Univent Replacement at Farley Elementary School
Univent Replacement at Willow Grove Elementary School
MSA File No. 42052

SED No. 50-02-01-06-0-003-011
SED No. 50-02-01-06-0-030-016

Re: ADDENDUM NO. 1

Drawing Title	ELECTRICAL FIRST FLOOR PLAN - 1
Drawing No.	FES-E-101

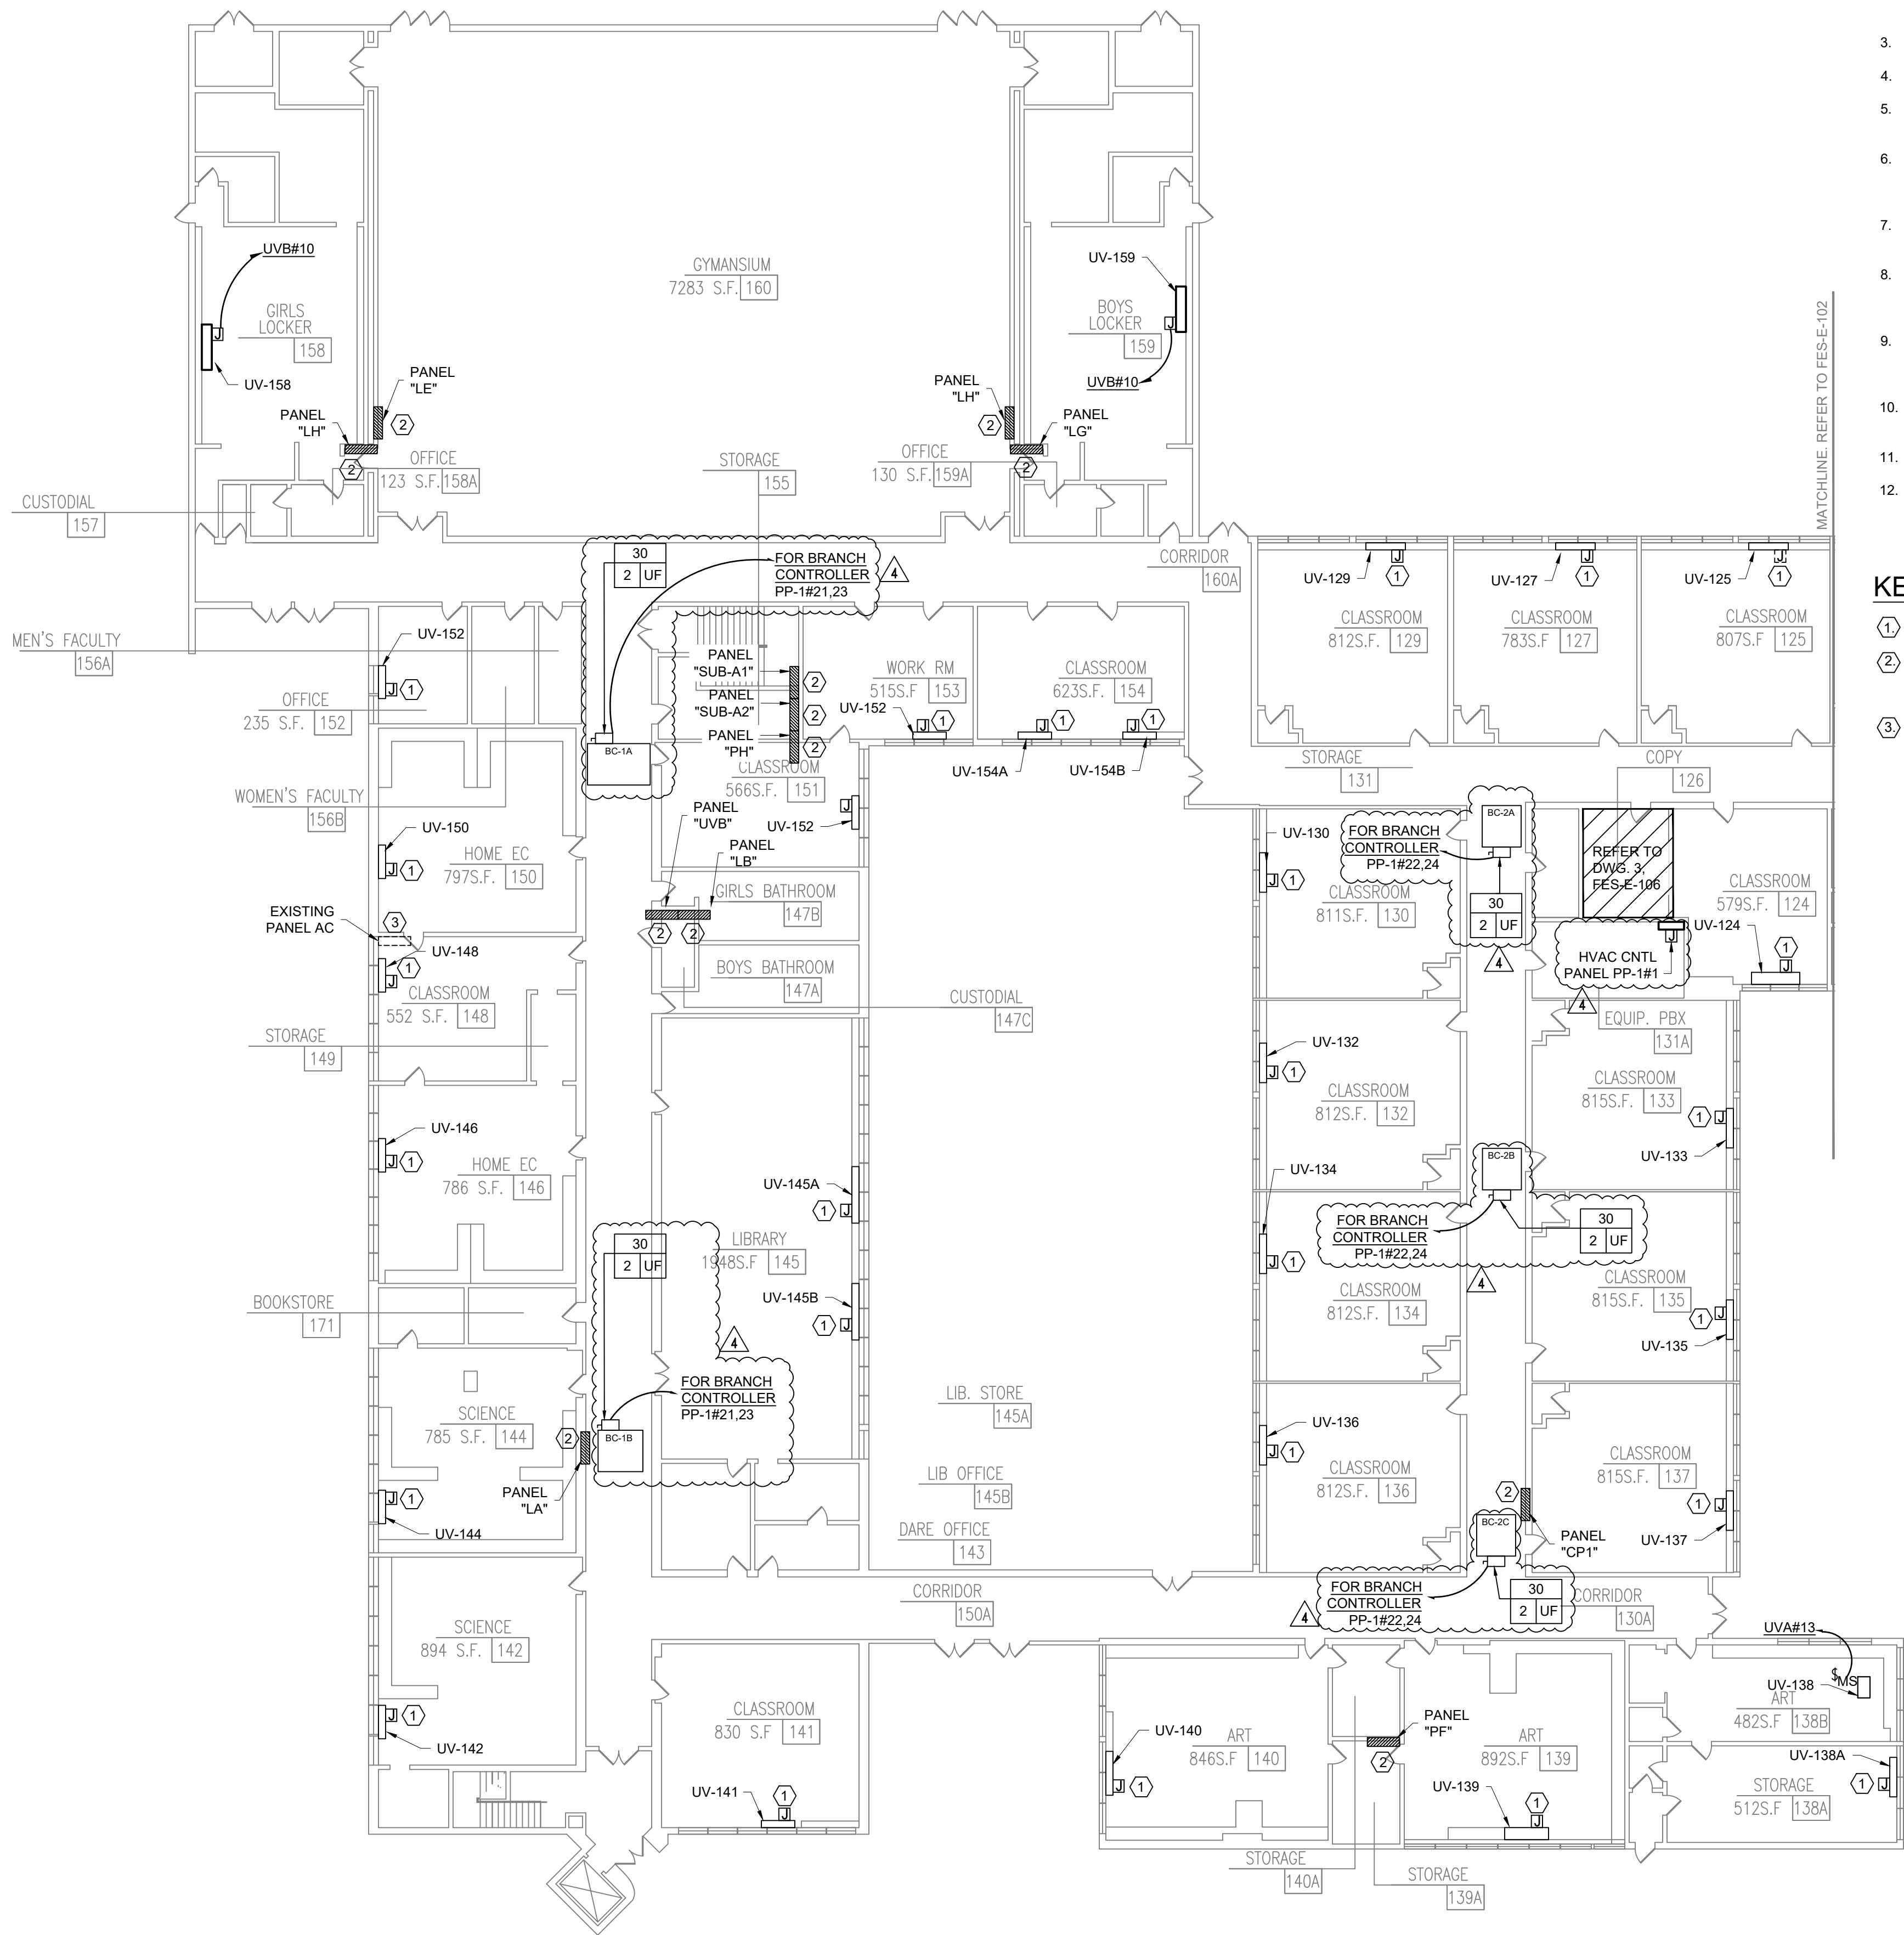
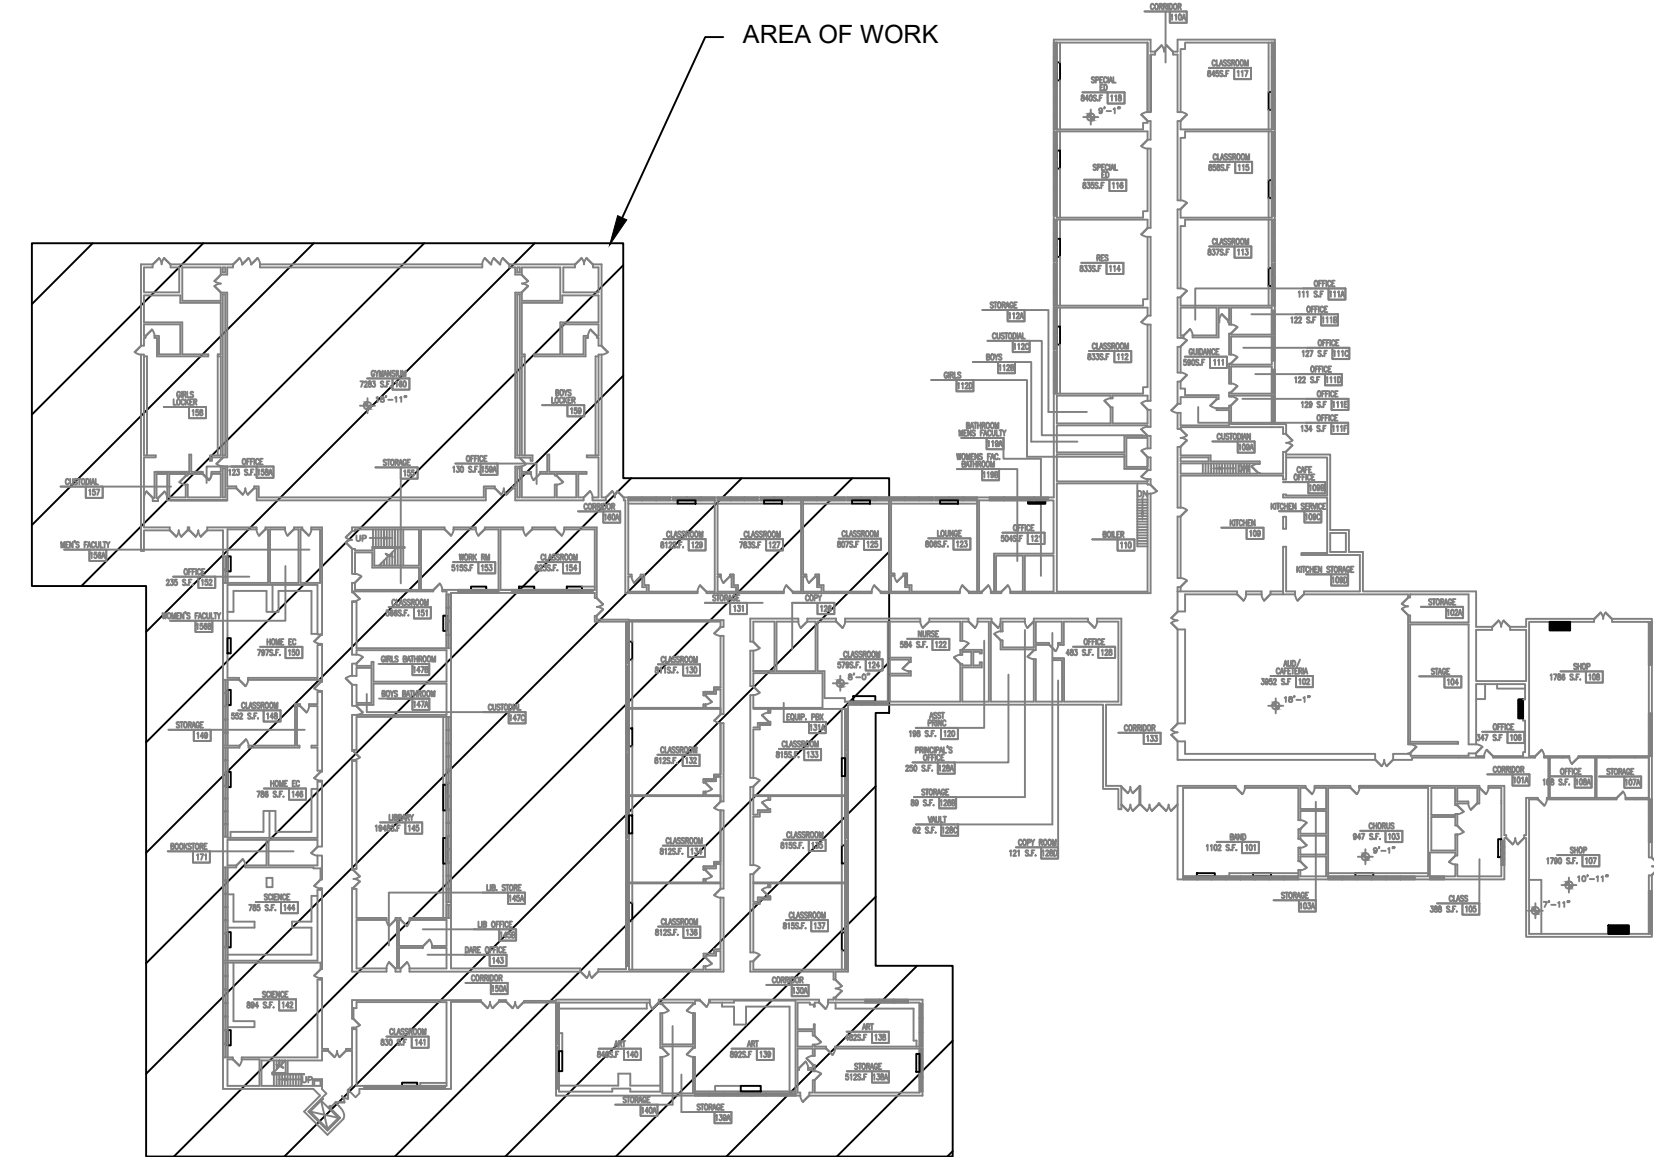
- 24) Drawing FES-M-504 has been added to the drawing set, dated 11-09-23, see attached.
- 25) Drawing FES-E-101 has been revised dated, 11-09-23, see attached. Revisions include updates to the branch controller locations.

Drawing Title	FES-E-102
FLOOR PLAN - 2

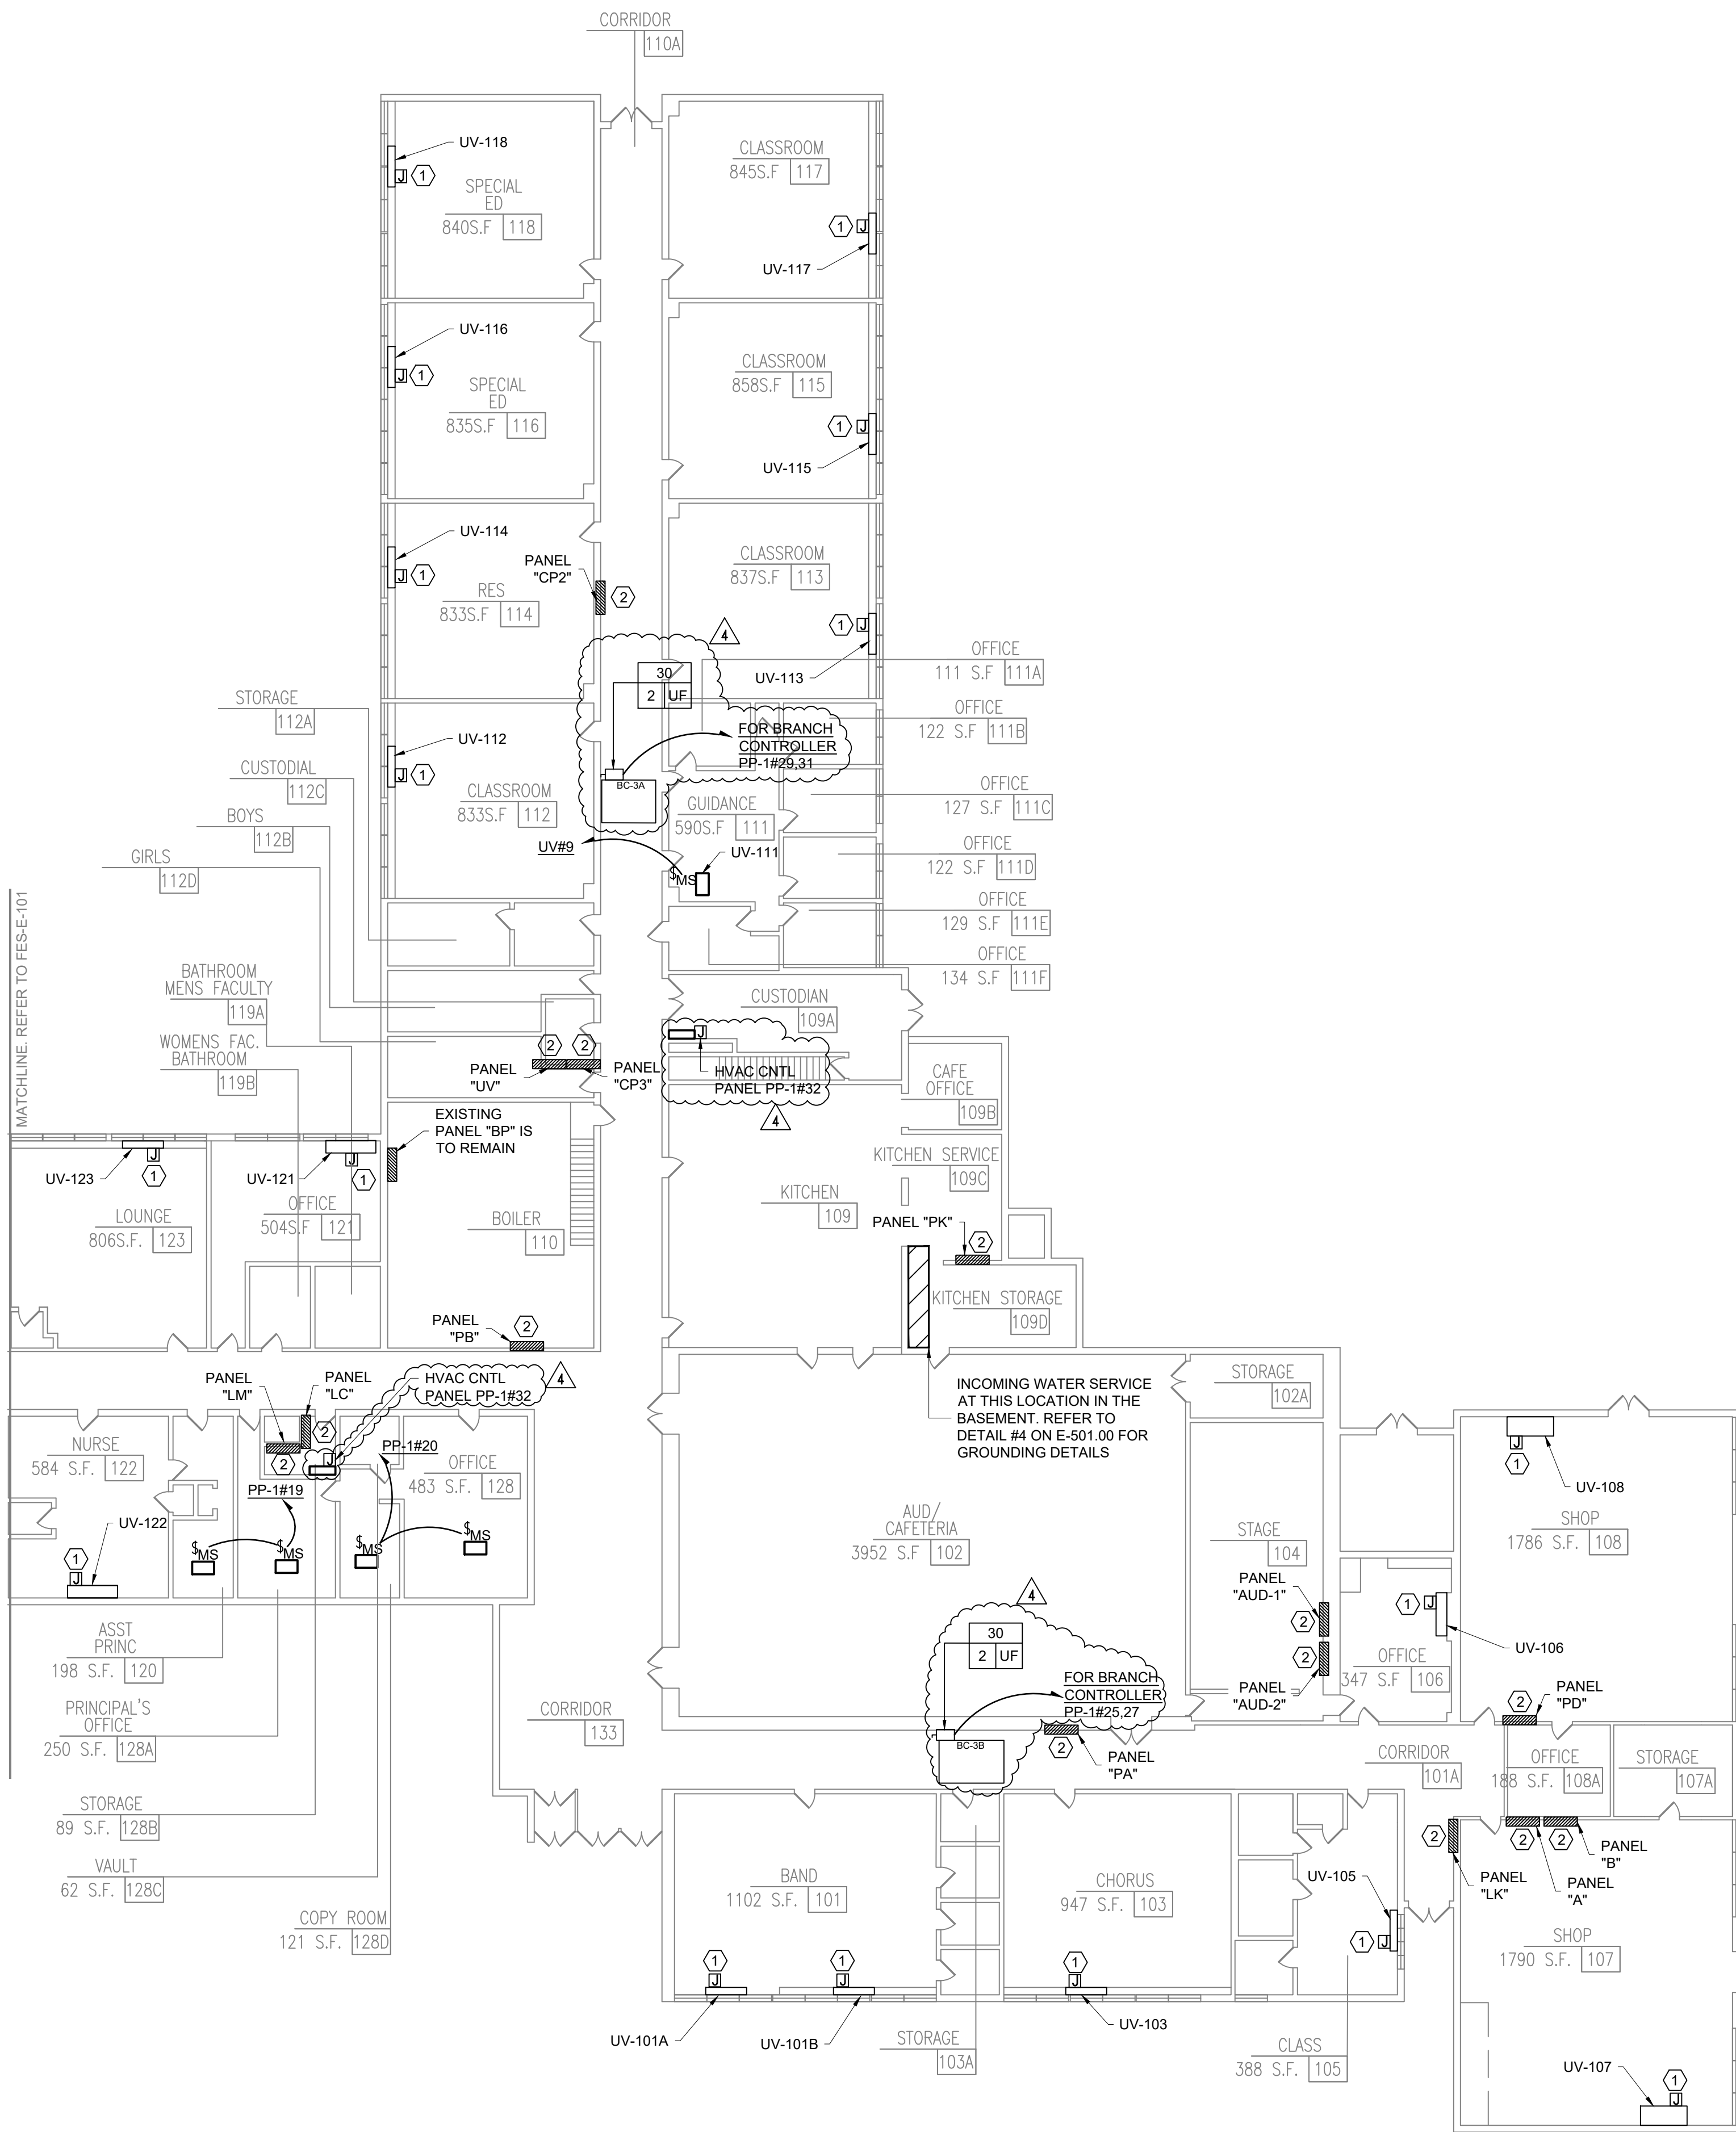
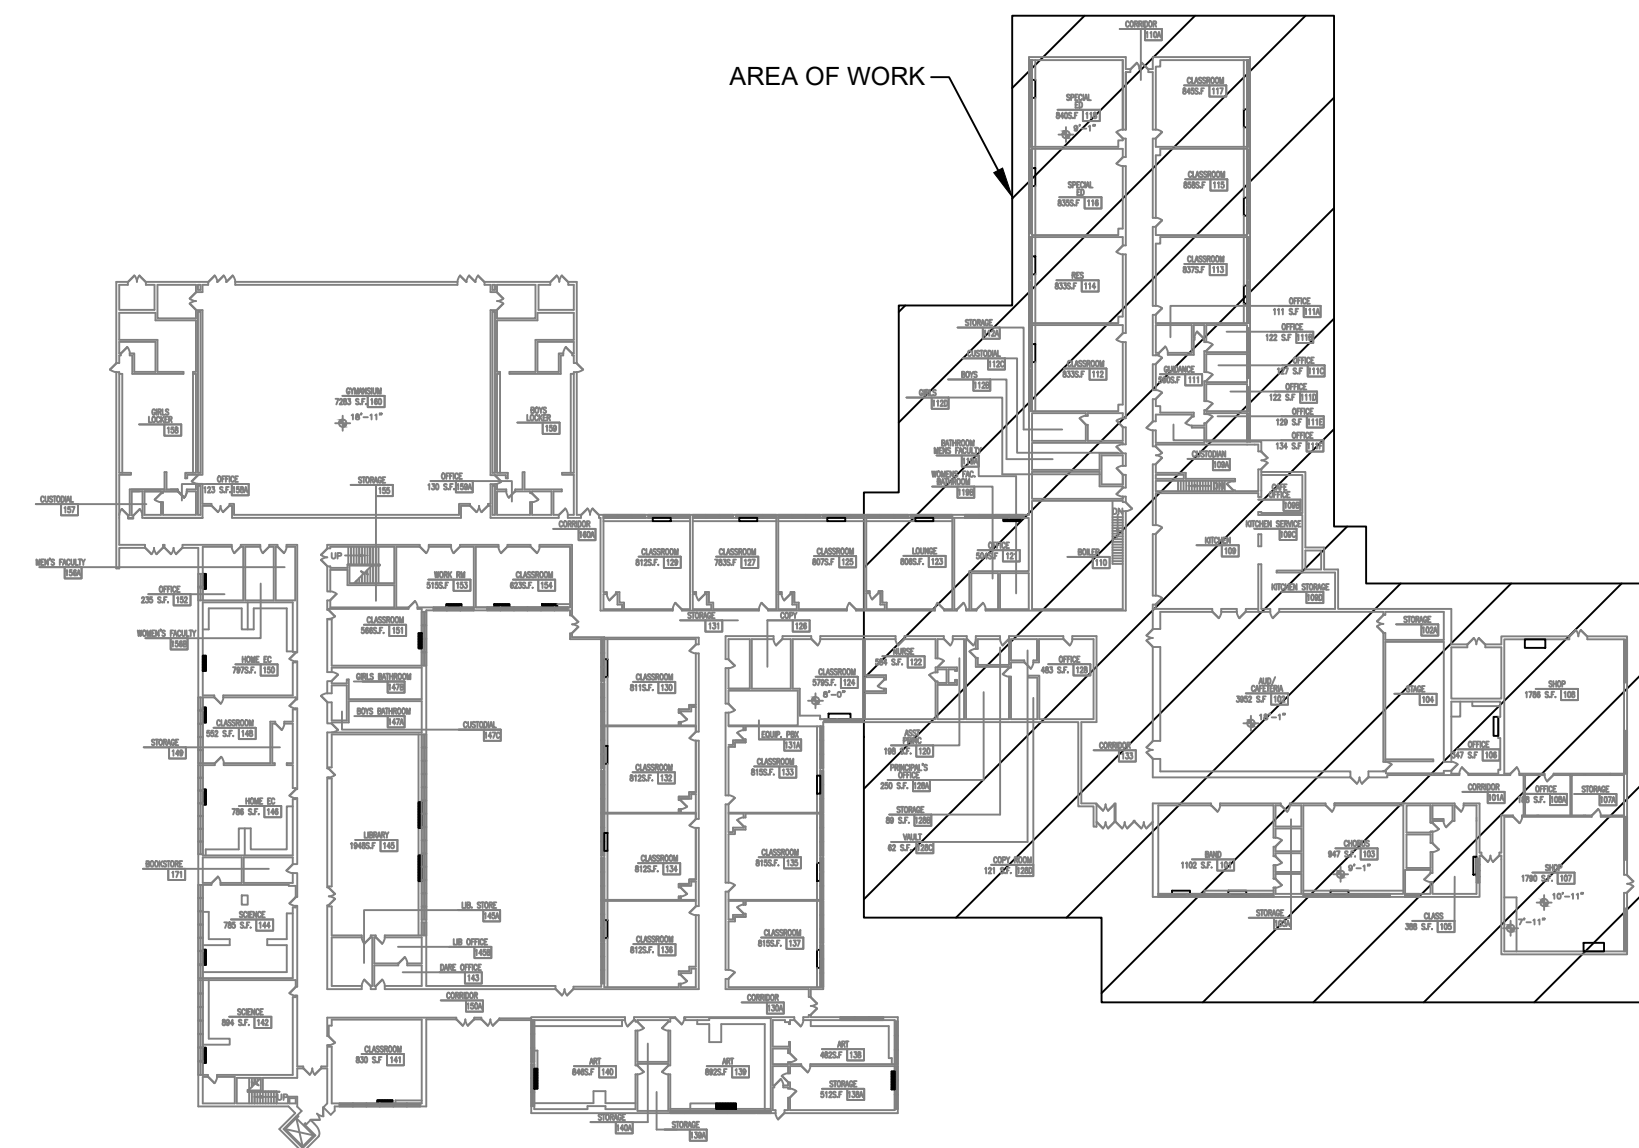
- 26) Drawing FES-E-102 has been revised dated, 11-09-23, see attached. Revisions include updates to the branch controller locations.
- 27) Drawing FES-E-104 has been revised dated, 11-09-23, see attached. Revisions include updates to the existing panel directories.
